Access Compliance Report

Public Rights-of-Way

Intersection ID: 29142	Main Street: APPLIEDALE_DR	Cross Street: BRIDGEVILLE_LN	Location:	N
ADA ID: 5B556845121D	Ramp Type: PerpDiag	Initial Pass/Fail: Fail	Overall Compliance: No	Severity Score: 21.25
Codes/Mitigation Info/Possible Solution		Field Measurements/Component Compliance

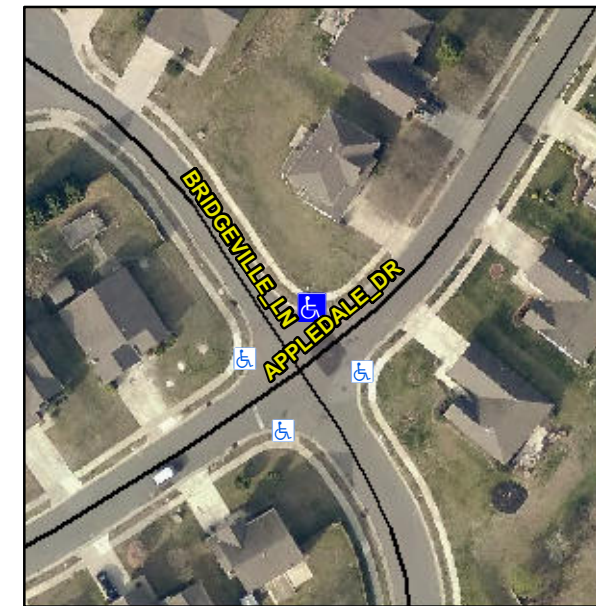
Not Found, R304.5.1, R304.5.3

Compliance	Description	Data	Compliance	Description	Data
N/A	Ramp Length (in)	47.0	Yes	Ramp Slope (%)	7.7
No	Ramp Width (in)	47.0	No	Ramp XSlope (%)	5.4
N/A	Flare Type LT	N/A	N/A	Flare Type RT	N/A
N/A	Flare Slope LT (%)	N/A	N/A	Flare Slope RT (%)	N/A
N/A	Flare Traversable LT?	N/A	N/A	Flare Traversable RT?	N/A
N/A	Landing Length (in)	N/A	N/A	DWS Provided?	N/A
N/A	Landing Width (in)	N/A	N/A	DWS Contrast?	N/A
N/A	Landing Slope (%)	N/A	N/A	DWS Length (in)	N/A
N/A	Landing X Slope (%)	N/A	N/A	DWS Full Width?	N/A
N/A	Landing Curb? (Y/N)	N/A	N/A	DWS Offset (in)	N/A
N/A	Shared Landing?	N/A			
N/A	Gutter Ponding?	N/A	N/A	Gutter Slope (%)	N/A
N/A	Gutter Lip Ht (in)	N/A	N/A	Gutter X Slope (%)	N/A
N/A	Painted X Walk1?	No	N/A	Painted X Walk2?	No
	X Walk 1 Direction	To W		X Walk 2 Direction	To S
N/A	X Walk 1 Width (in)	N/A	N/A	X Walk 2 Width (in)	N/A
	X Walk 1 Slope (%)	5.1		X Walk 2 Slope (%)	1.5
	X Walk 1 X Slope (%)	1.4		X Walk 2 X Slope (%)	6.4

Remove & Replace Curb Ramp With Two New Directional Ramps or Equivalent.
